# CITY OF ALBUQUERQUE

**Re: Good to Go: Broadway  
1401 Broadway Blvd.  
Traffic Circulation Layout**  
Engineer's Stamp dated 1-17-18 (L14D022)

The TCL submittal received 1-18-18 is approved for Building Permit. A copy of the stamped and signed plan will be needed for each of the building permit plans. Please keep the original to be used for certification of the site for final C.O. for Transportation.

C1.2

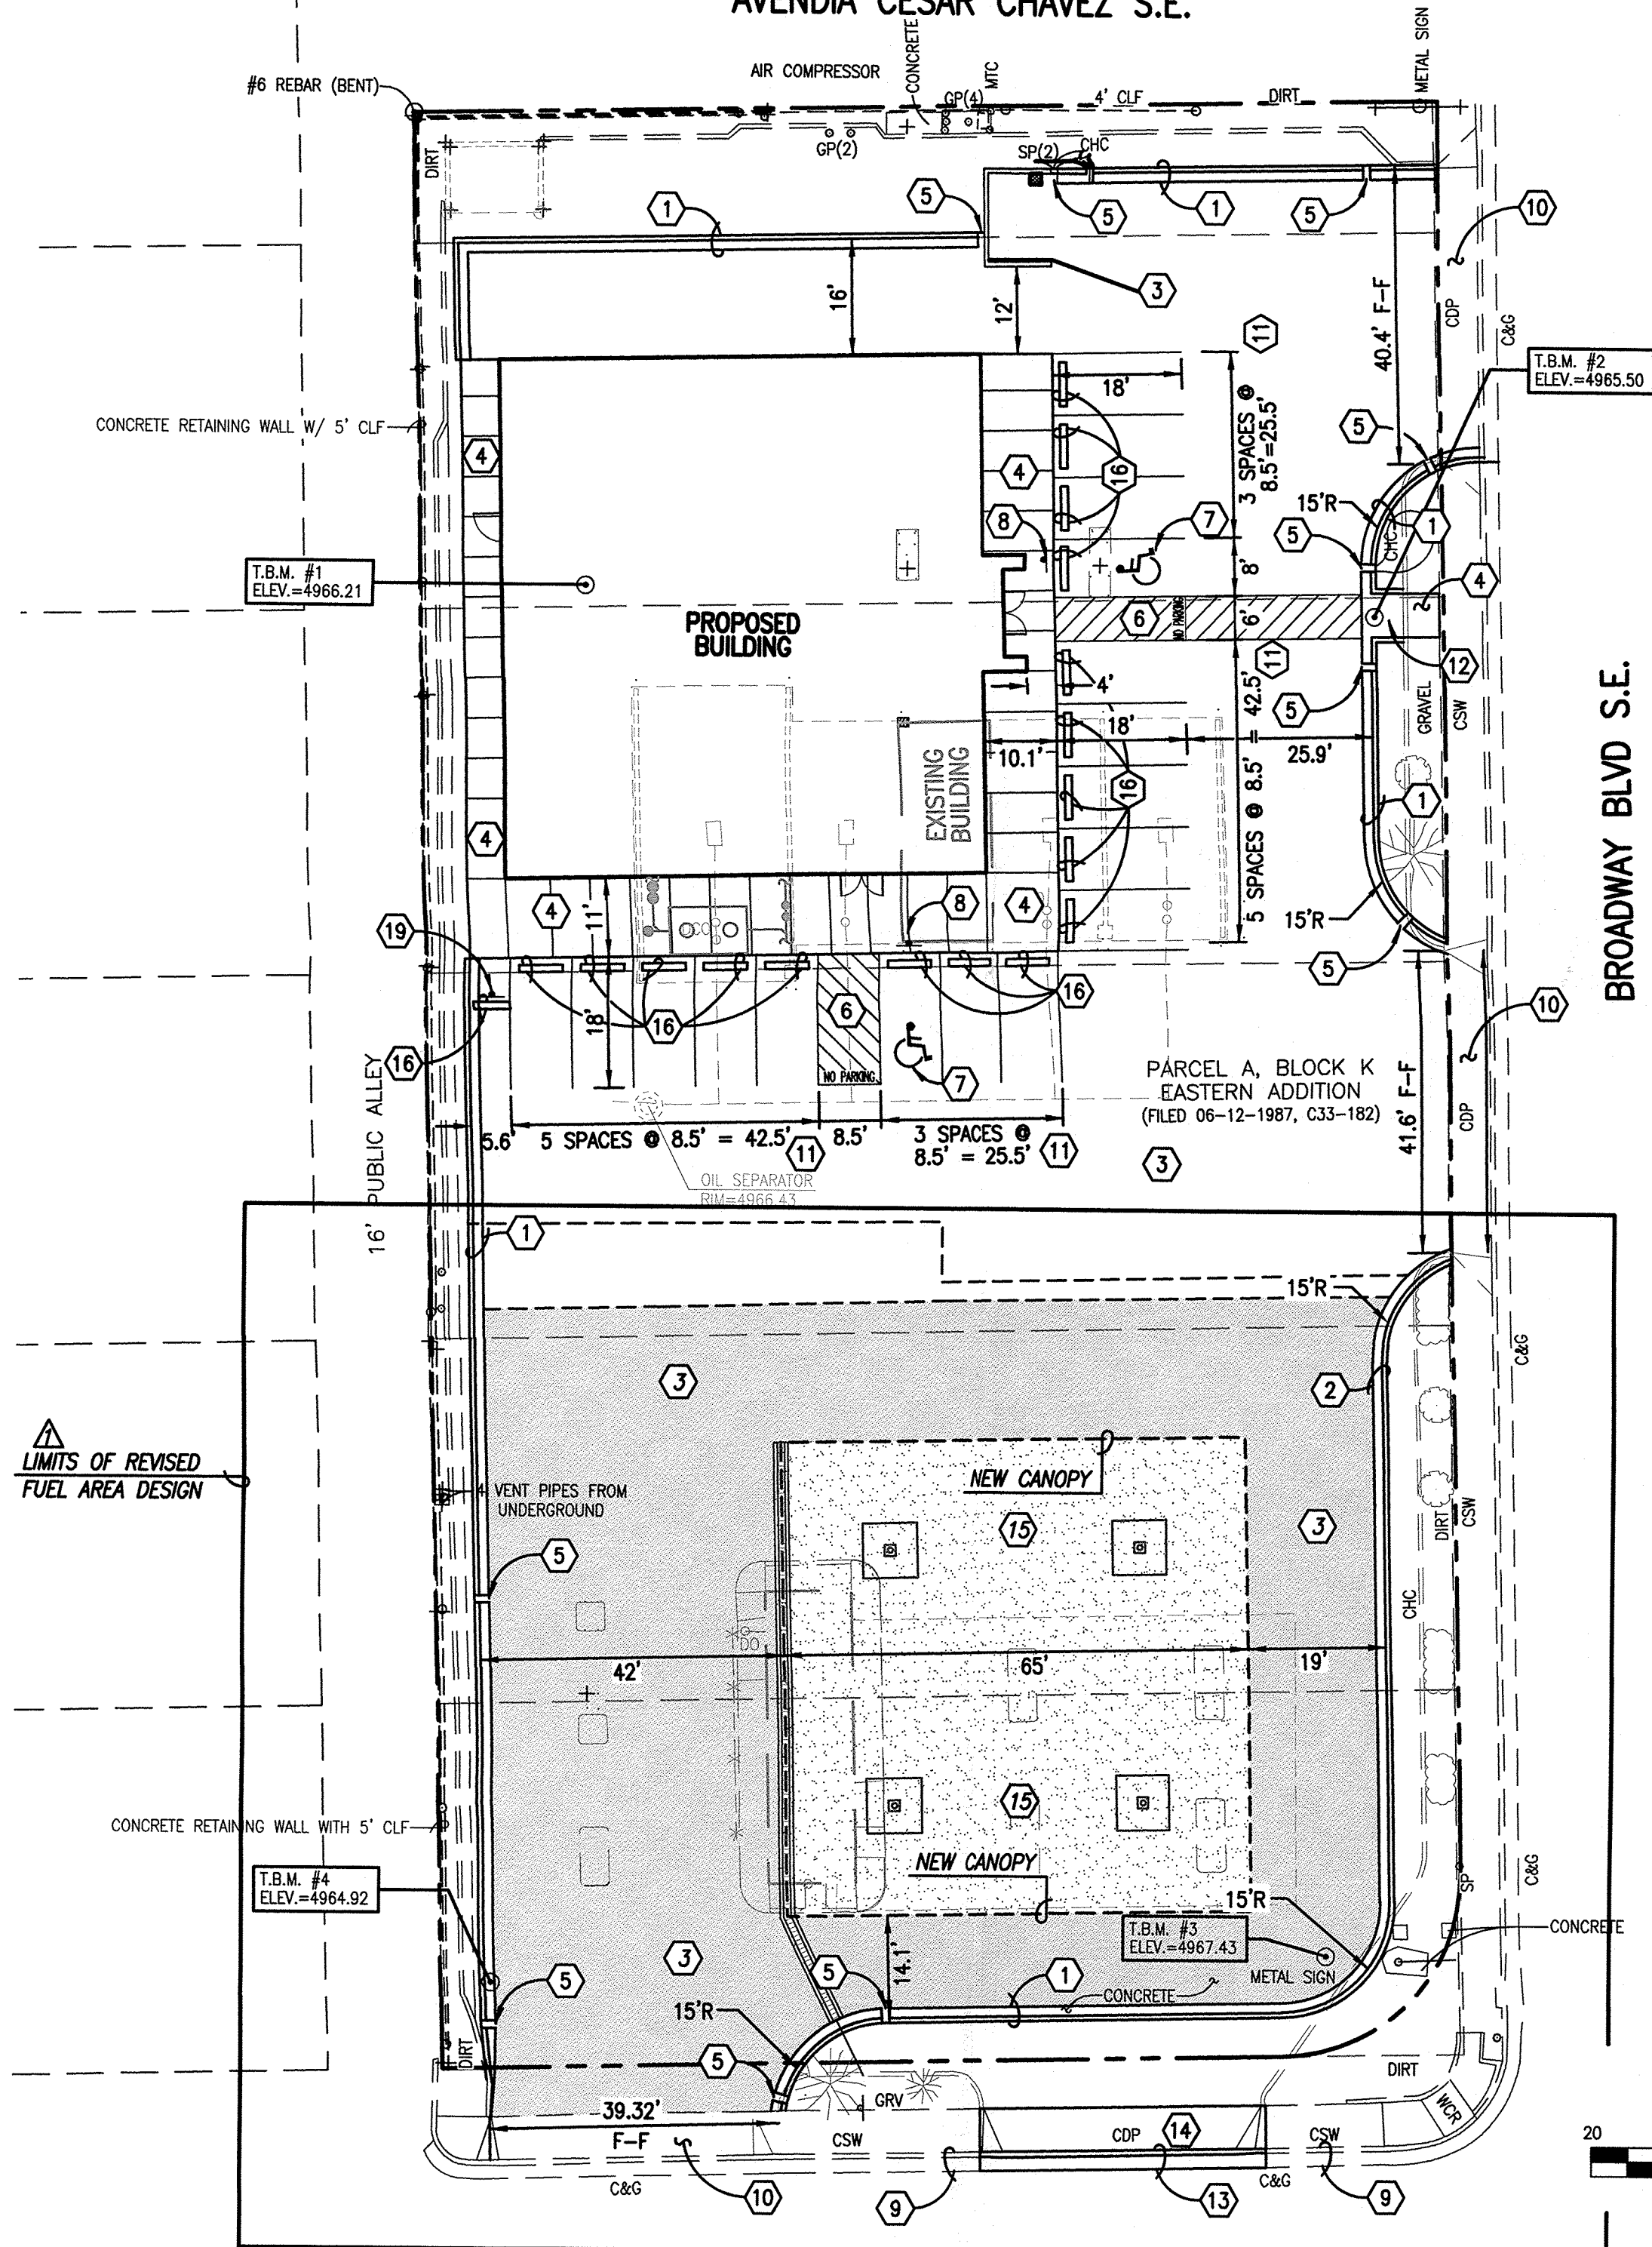
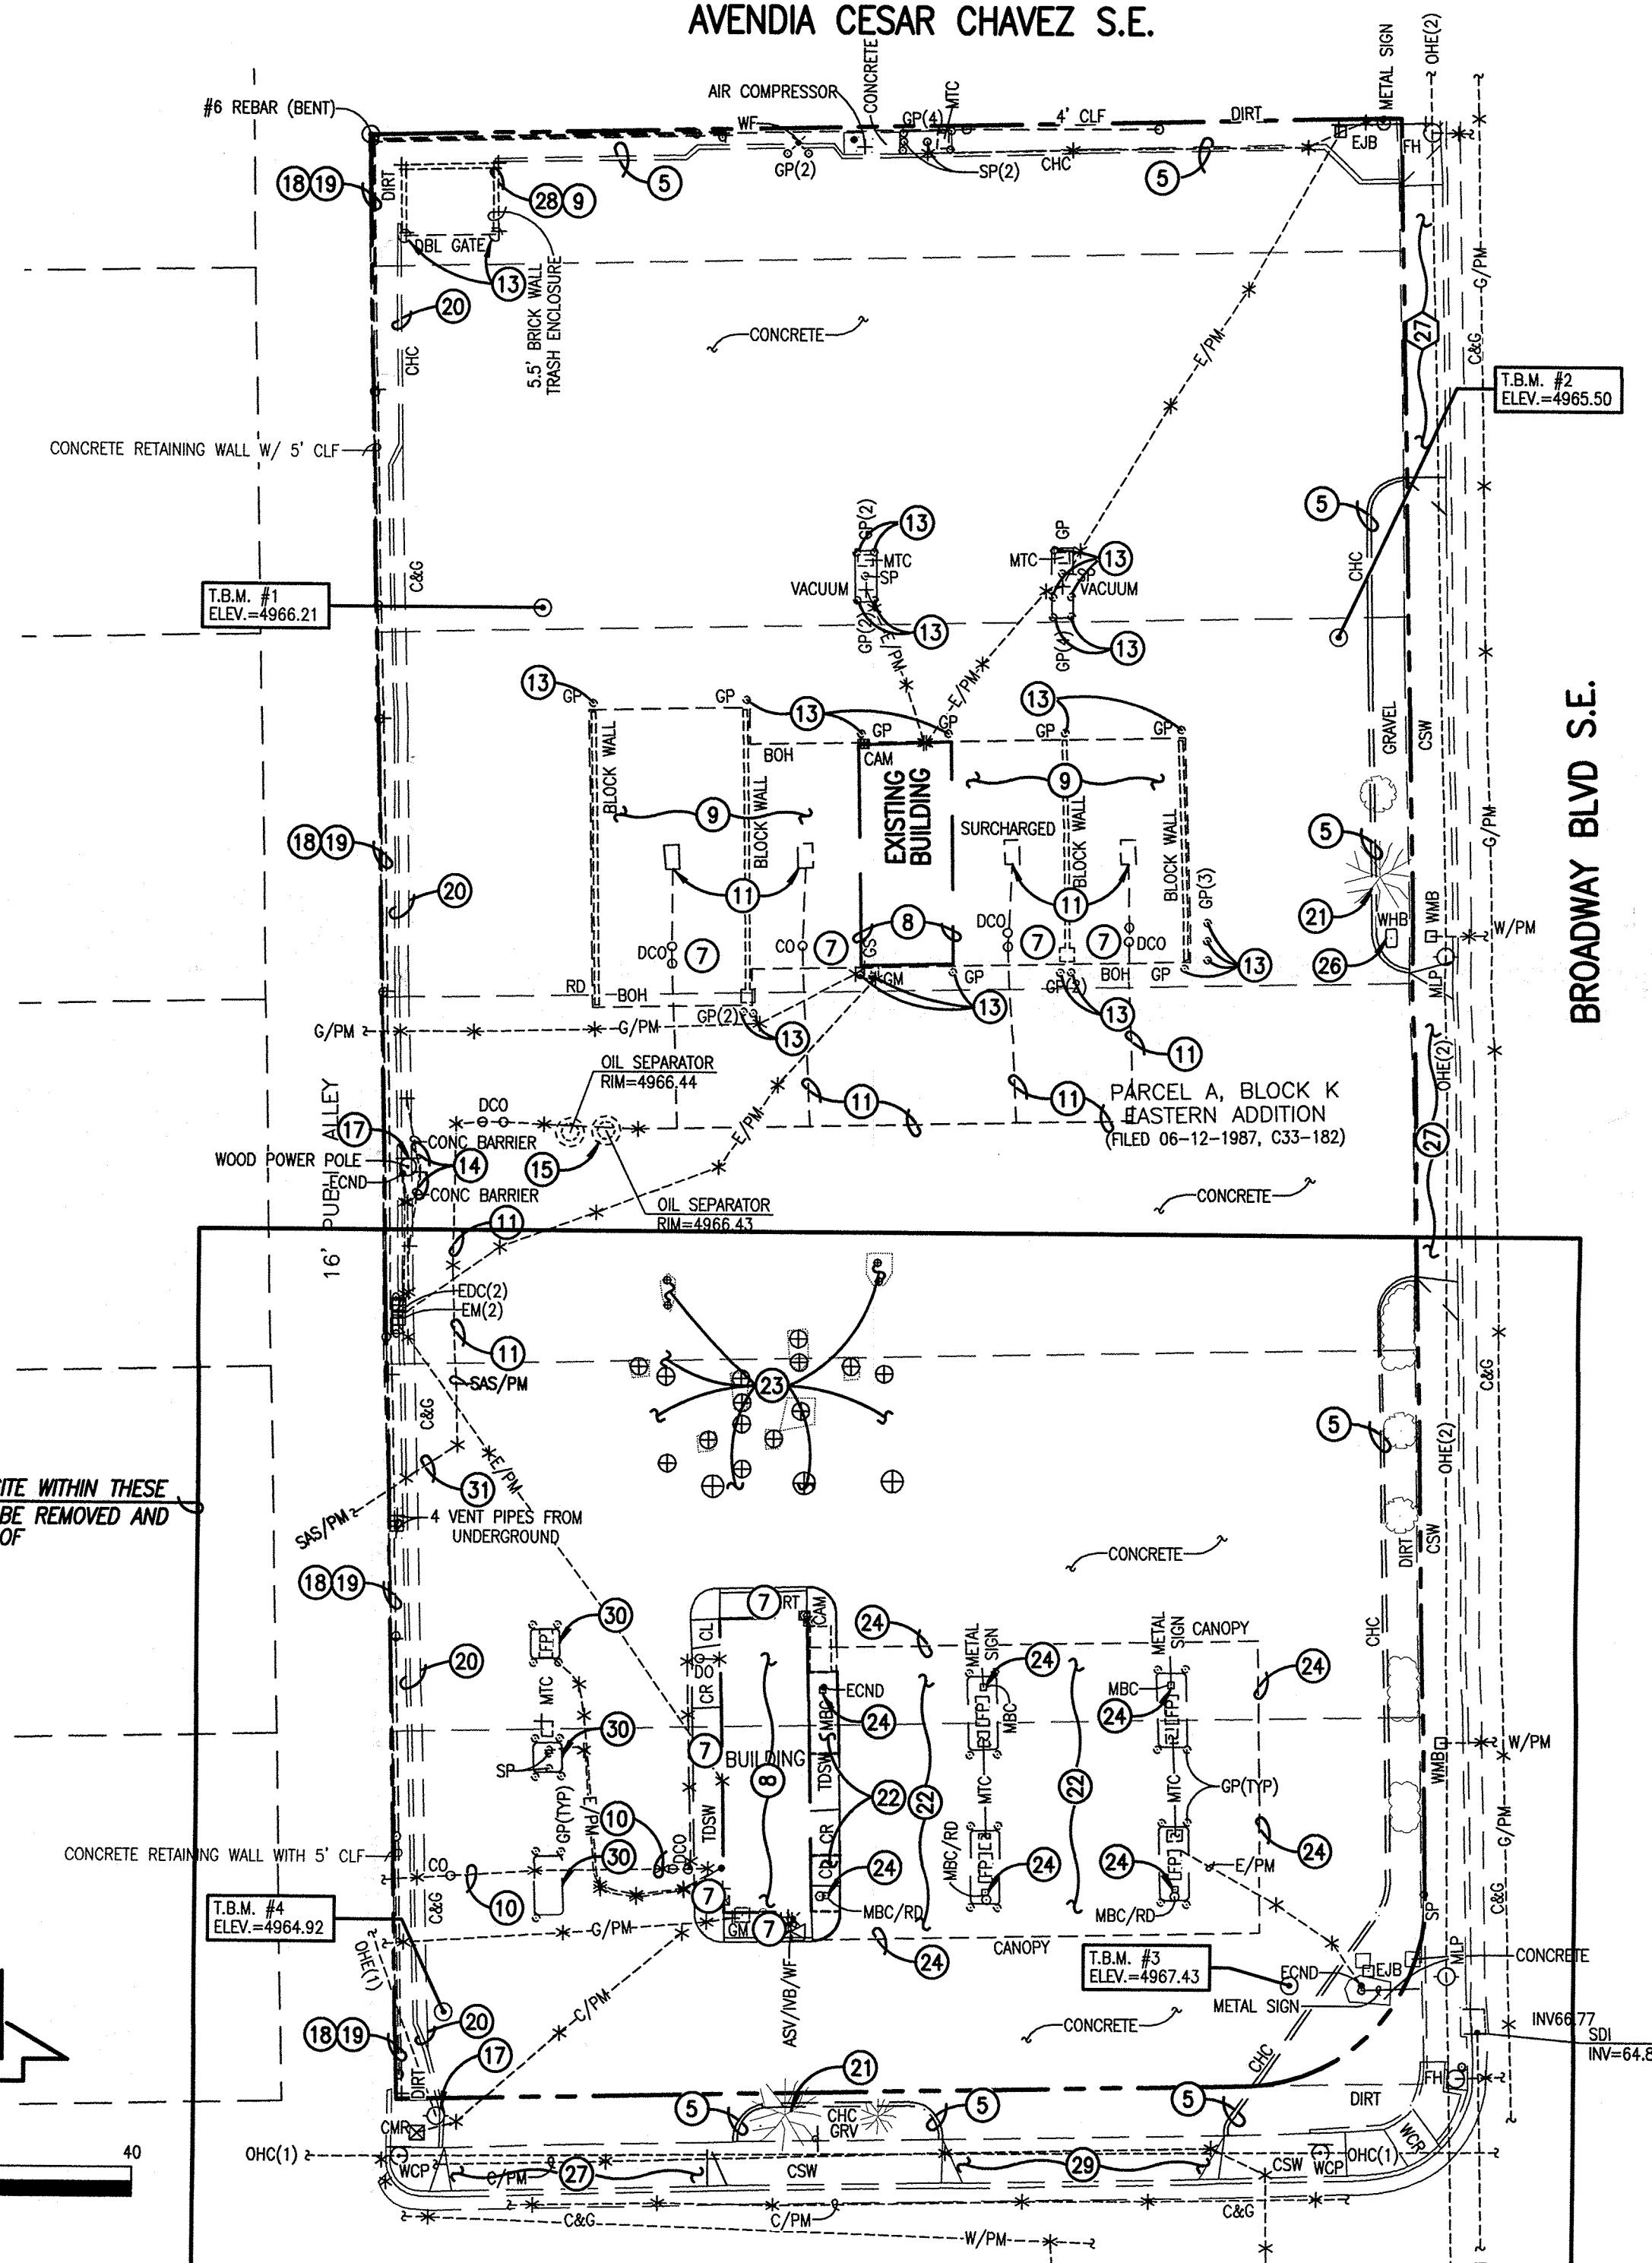
When the site construction is completed and a Certificate of Occupancy (C.O.) is requested, use the original City stamped approved TCL for certification. Redline any minor changes and adjustments that were made in the field. A NM registered architect or engineer must stamp, sign, and date the certification TCL along with indicating that the development was built in "substantial compliance" with the TCL. Submit this certification TCL with a completed Drainage and Transportation Information Sheet to front counter personnel for log in and evaluation by Transportation.
